Aqueous Solutions (owner) AQS-MFG-ROLL-HD01
ROLL fabrication drawing HD01 (AQS-PLAN-006 M3; graph Rev AD
Type: fabrication drawing (GA / nozzle orientation / part sheet) Rev 8880561d Issued
Created: flow graph pipeline Approved: not approved (study)
Sheet 1 of 1 AQS-DWG-001

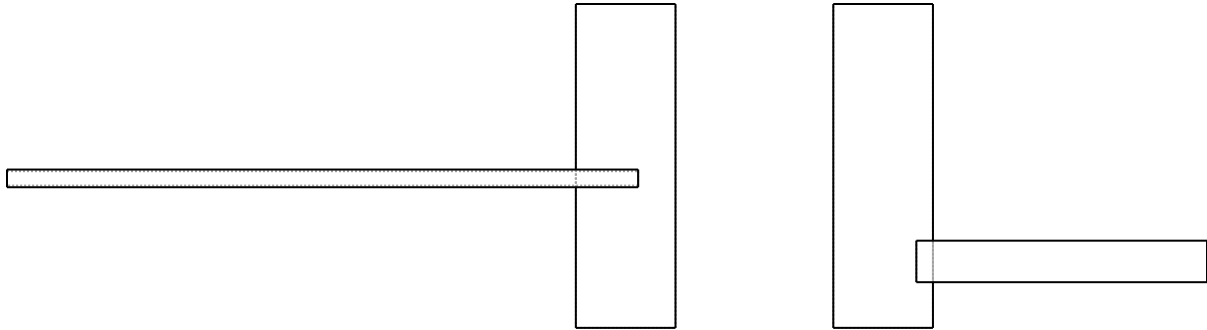
Graph revision AC - hd01: Screw-down OD 50, z 1150..1500, from the top-roll chock to the frame datum
Graph revision AC - hd01: Roll chocks cross the stand +X face by 20 mm (no coplanar seam); N5 vent riser DN15 to z 800
Graph revision AC - hd01: General tolerance ISO 2768-m unless noted
